## **Addendum No. 1**

To: **All Contractors**  
Date: May 10, 2022  
Re: **Lincoln County Ambulance District**  
Base Station 2  
28 Walter Court  
Moscow Mills, Missouri 63362

New Base Station #2 Facility for:  
**Lincoln County  
Ambulance District**  
28 Walter Court  
Moscow Mills, Missouri 63362

SHEET  
**P300**  
PLUMBING  
ISOMETRICS

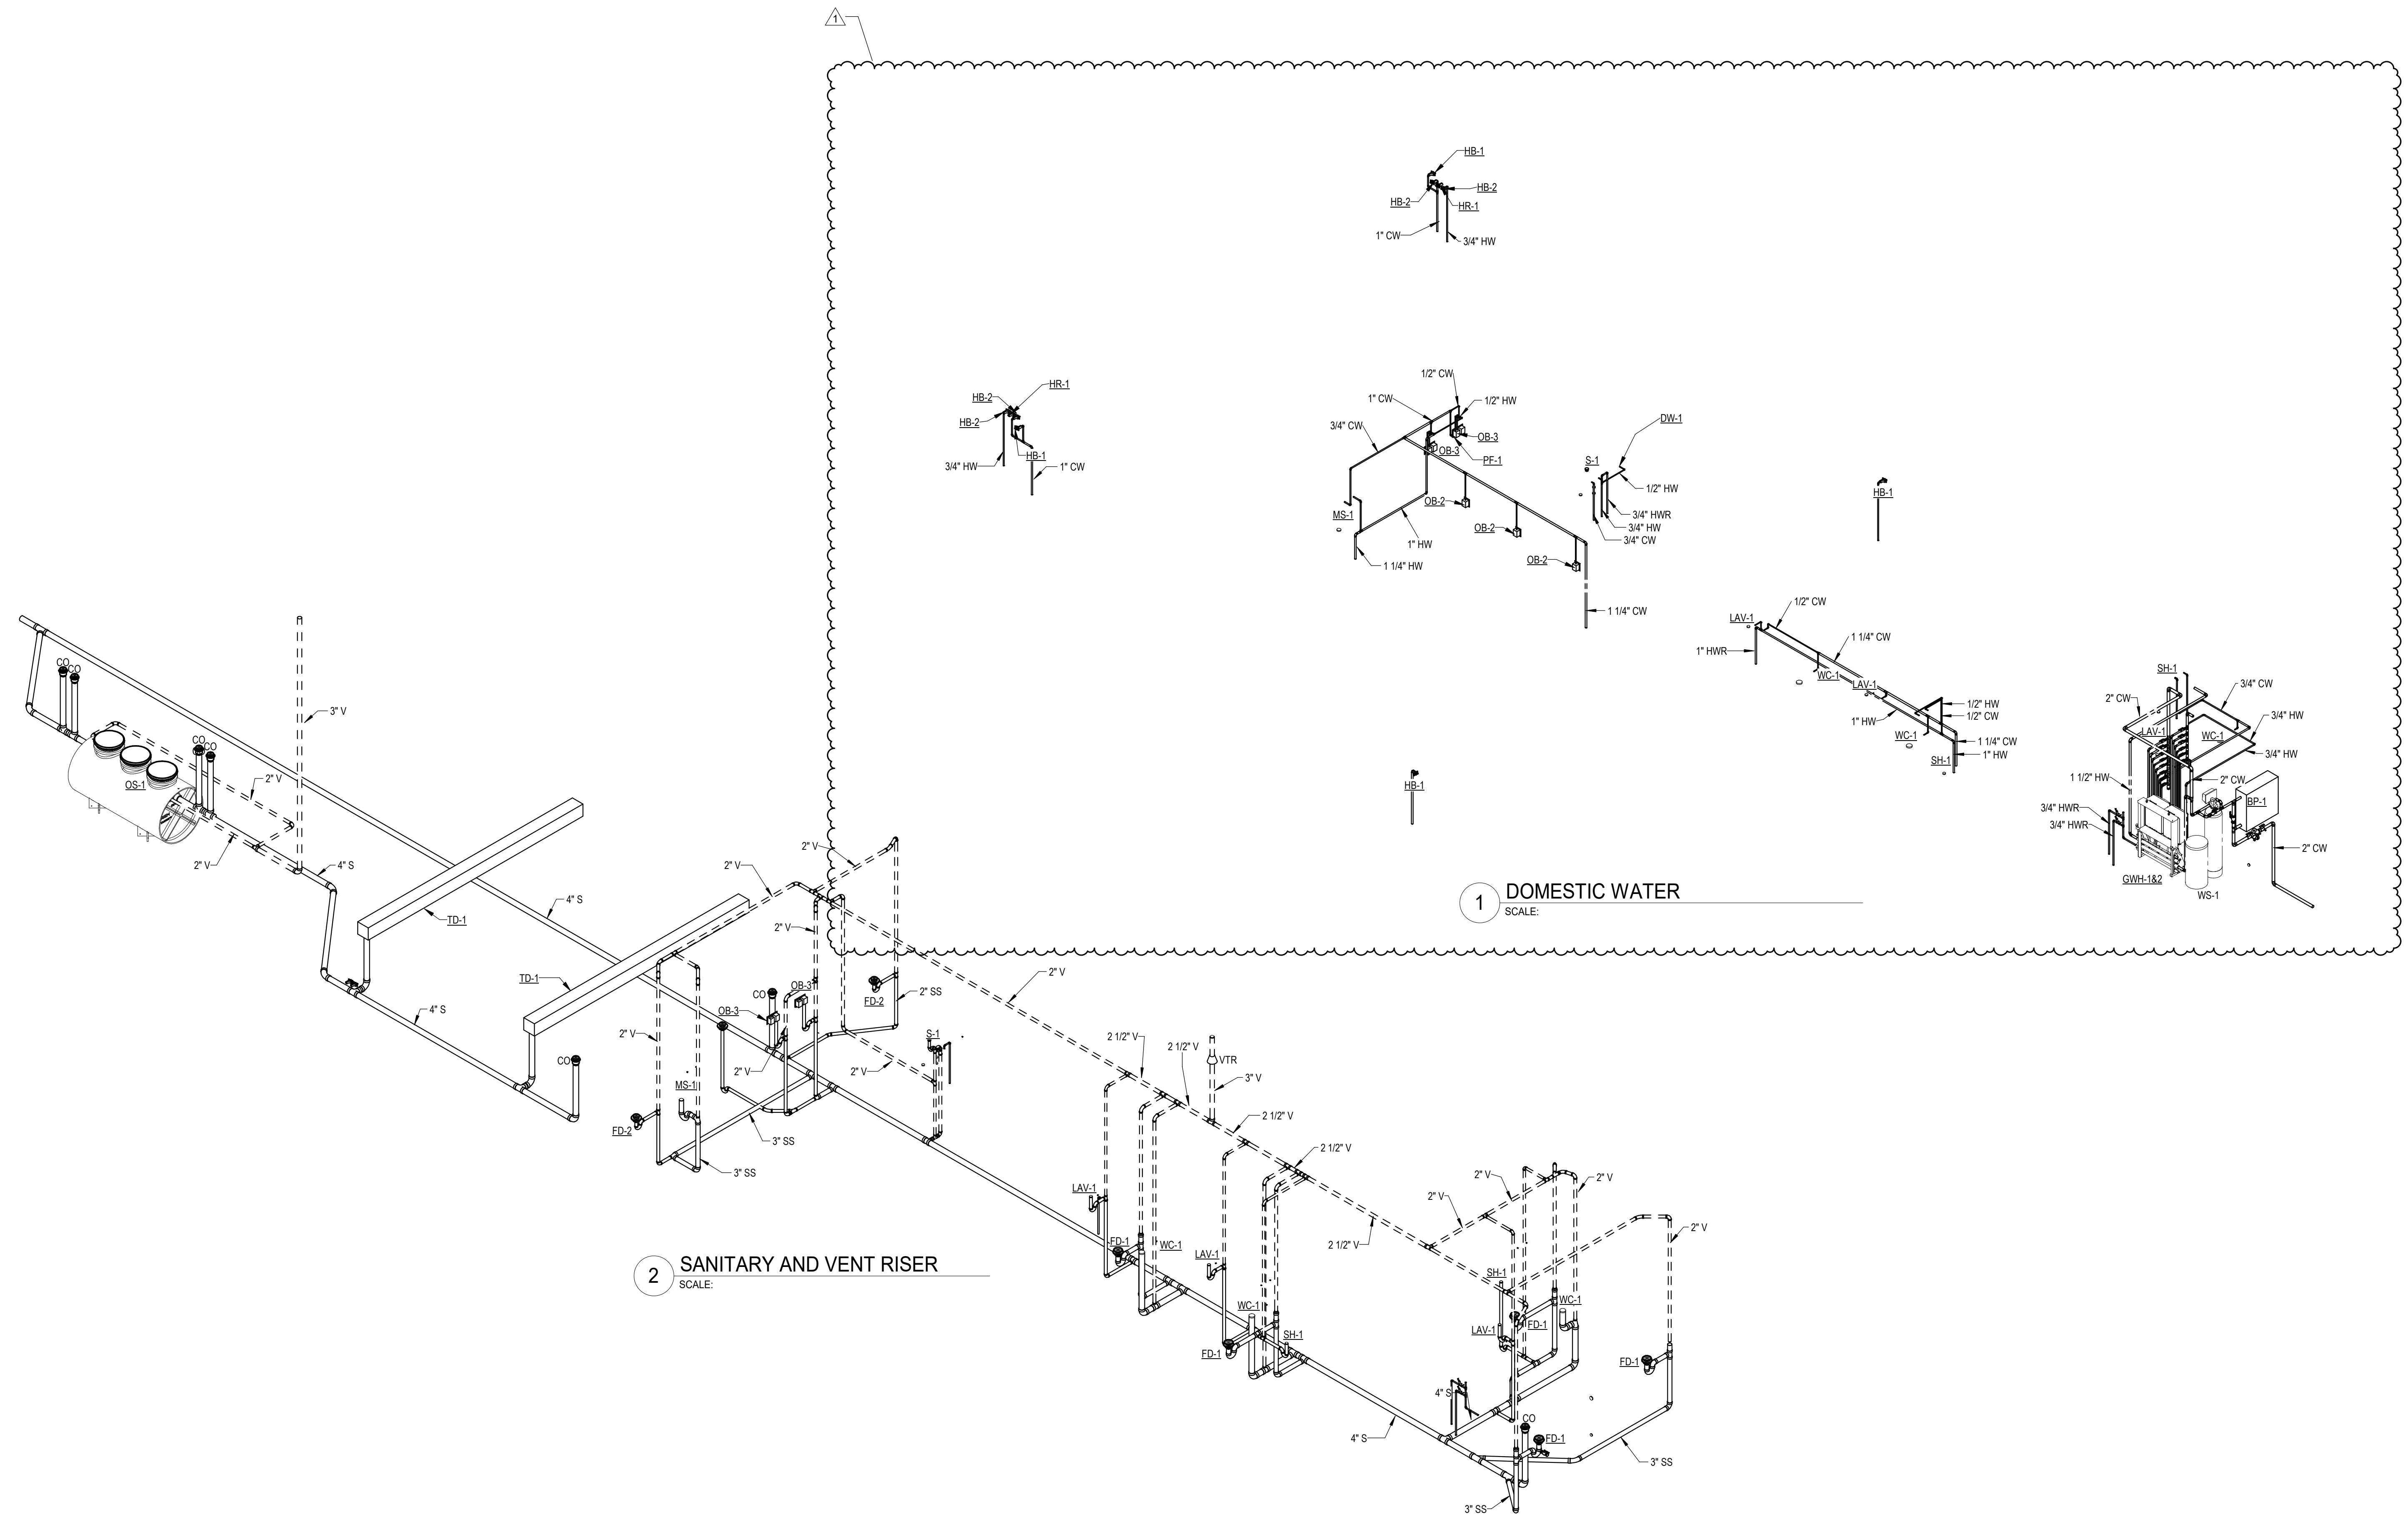
- b. Added Domestic Water Manifold Detail.
11. Sheet P300, Plumbing Isometrics – Revised drawing issued.
  - a. Domestic Water Isometric Plan - Revised domestic water lines to below grade.

SHEET  
**E1.0**  
 POWER ONE-LINE  
 & PANEL SCHEDULES

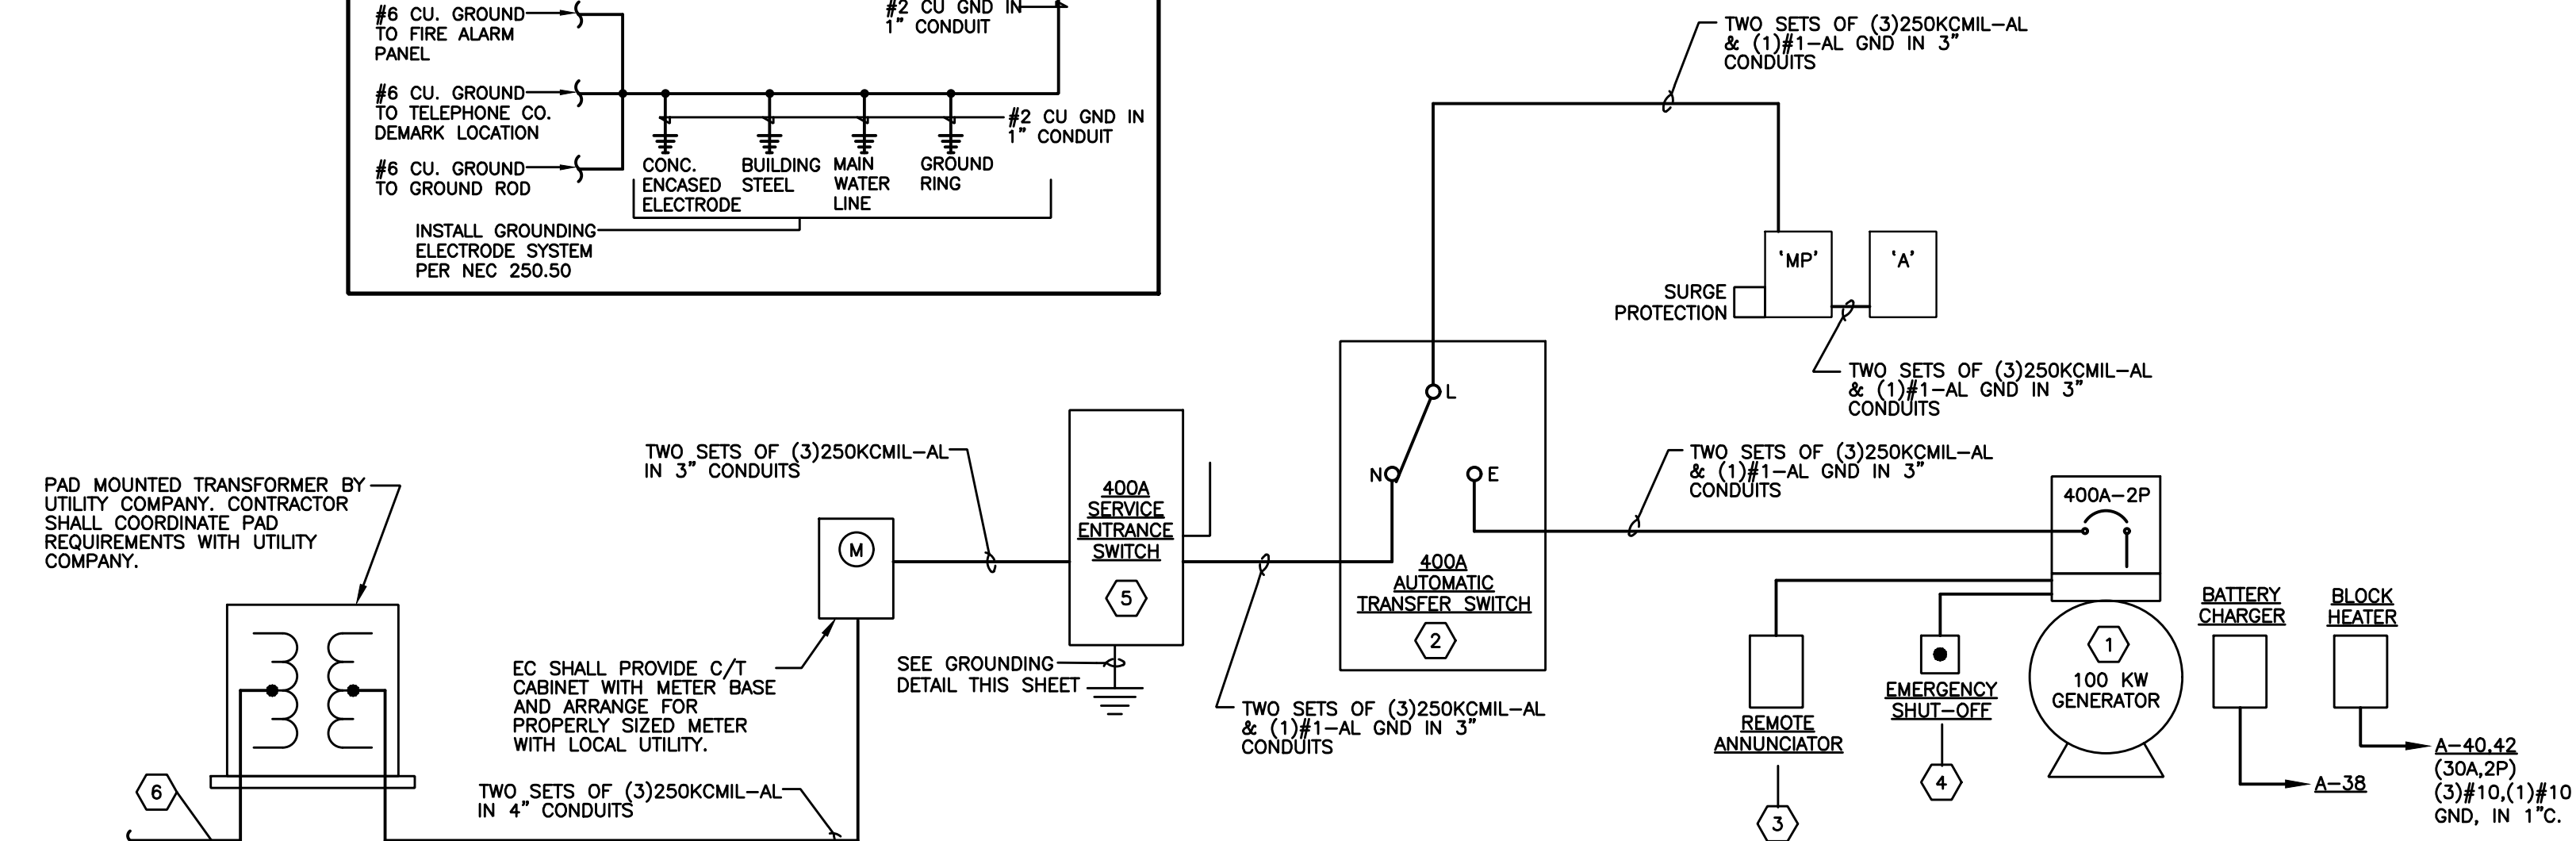
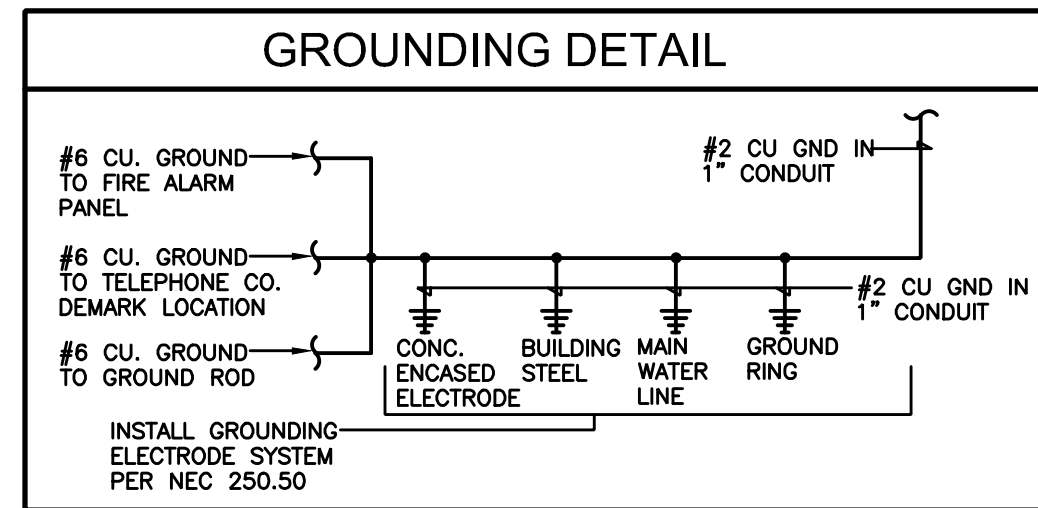
12. Sheet E1.0, Power One-Line and Panel Schedules – Revised drawing issued.
  - a. Revised the Panels to accommodate the voltage change of the split system unit.

SHEET  
**E3.0**  
ELECTRICAL POWER PLAN

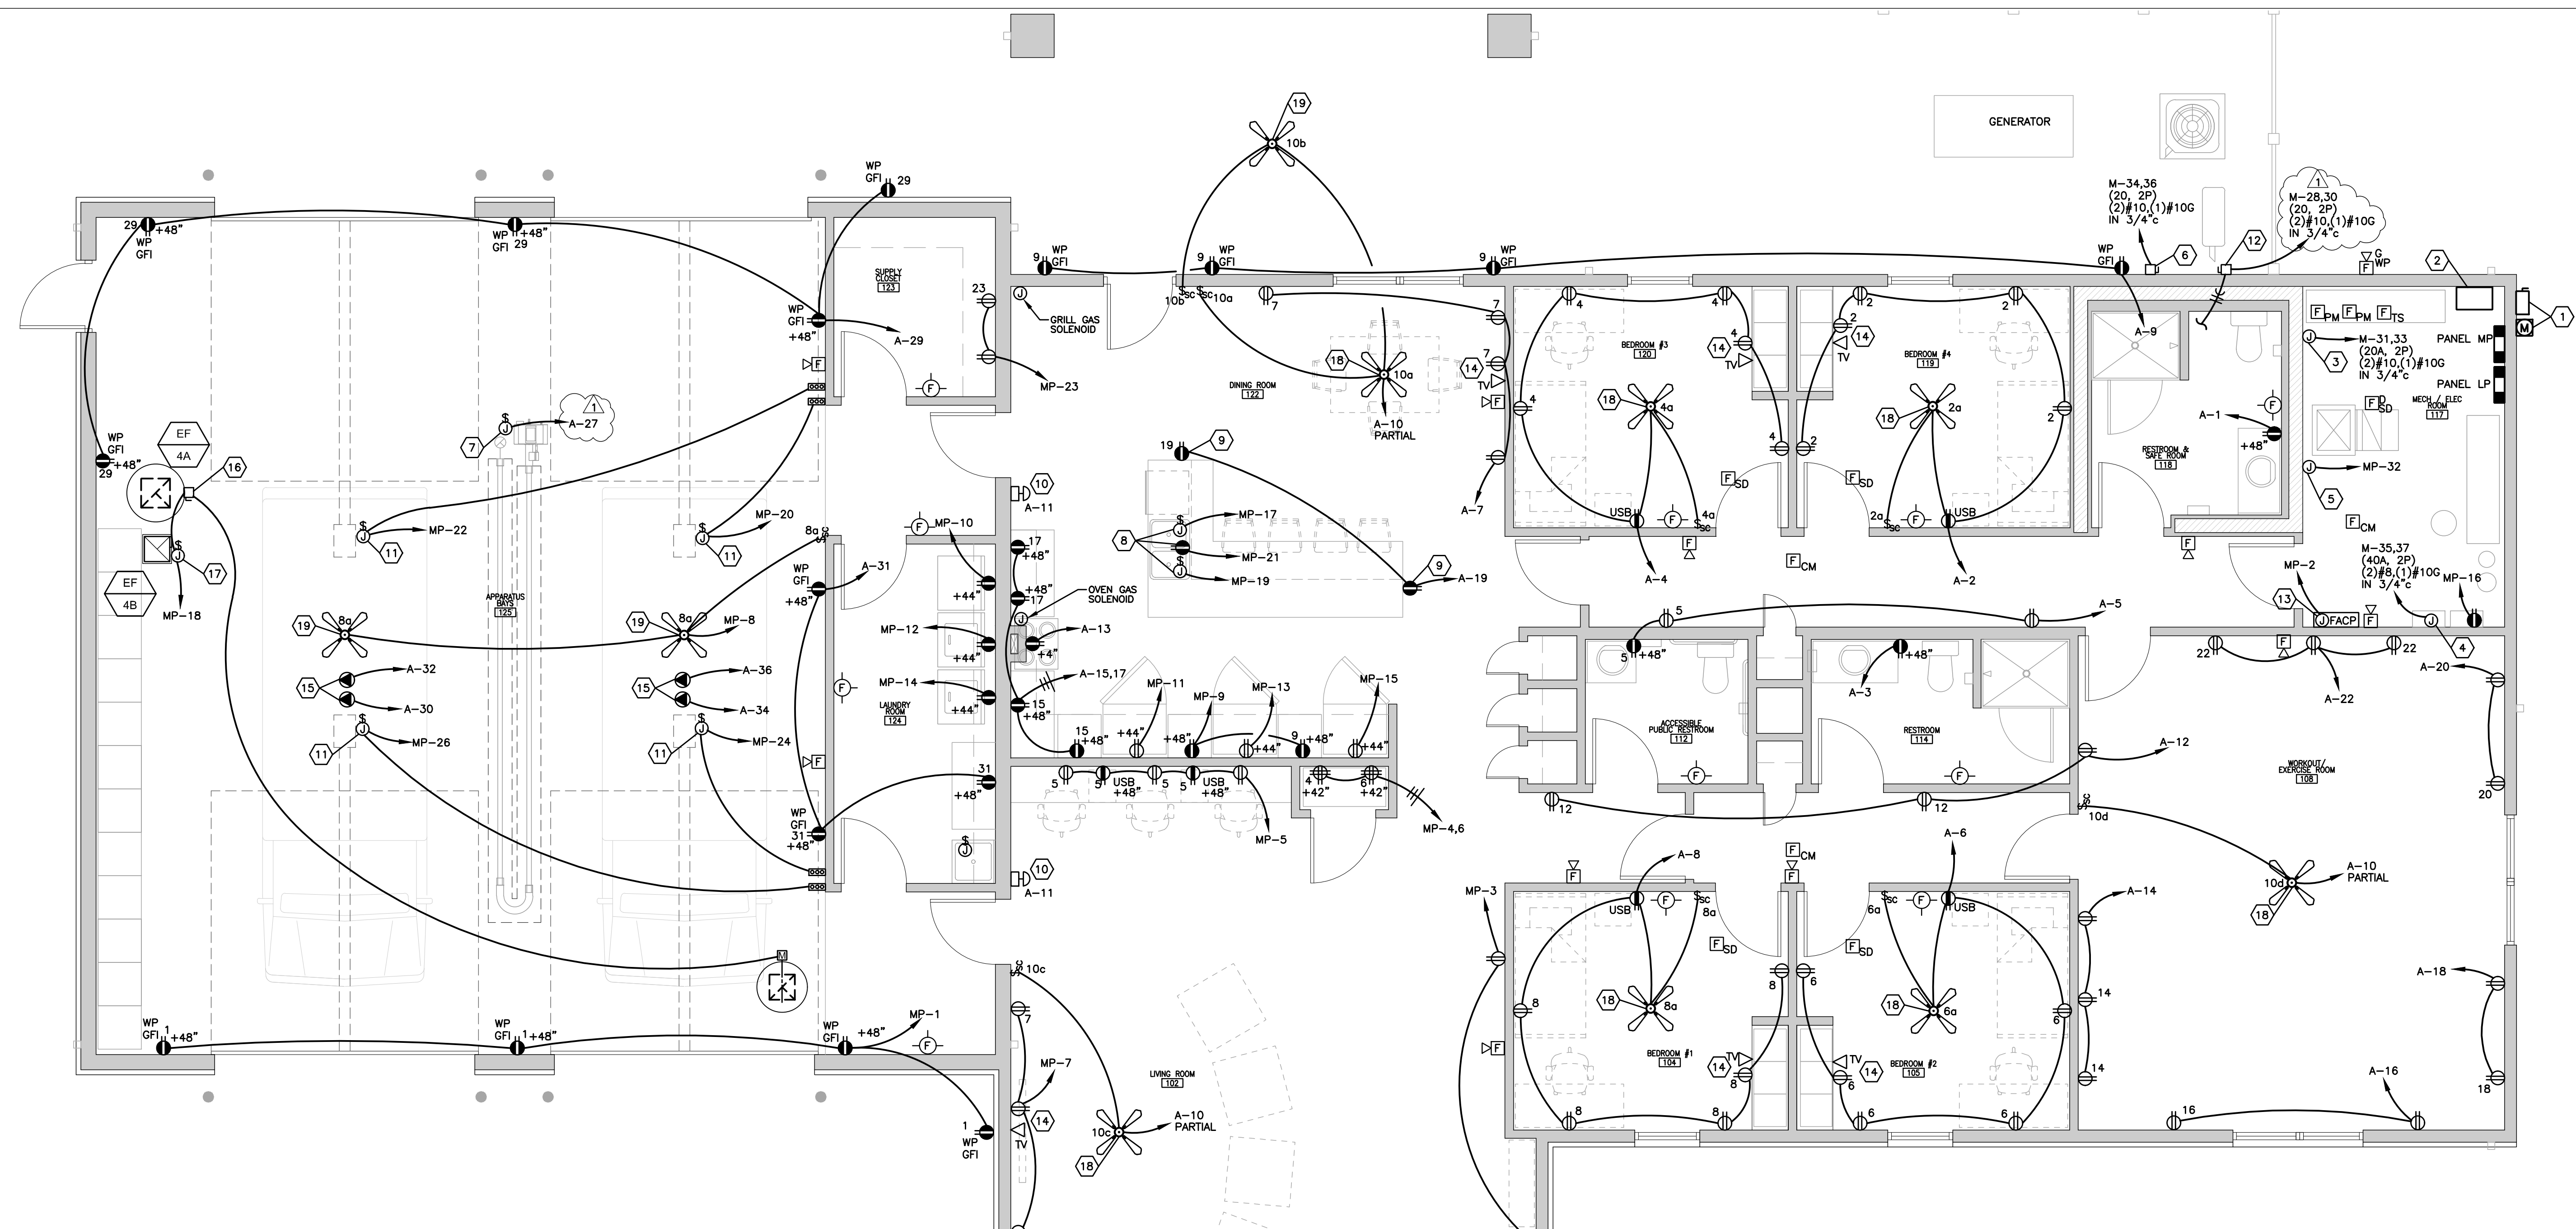
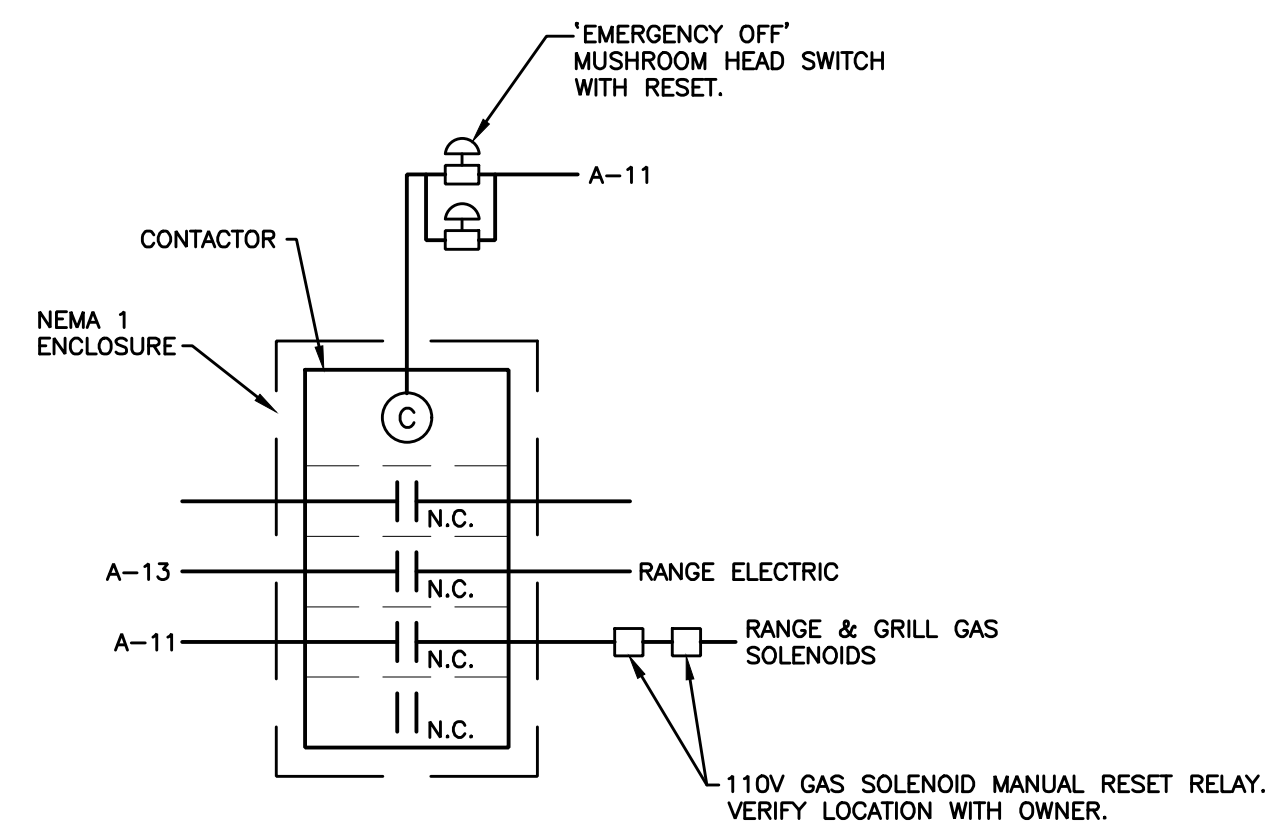
13. Sheet E3.0, Electrical Power Plan – Revised drawing issued.
  - a. Revised the split system Keyed Note 12 and home run to match unit.
  - b. Revised the homerun for the bay heater to make room for the split system change in the panel schedule.
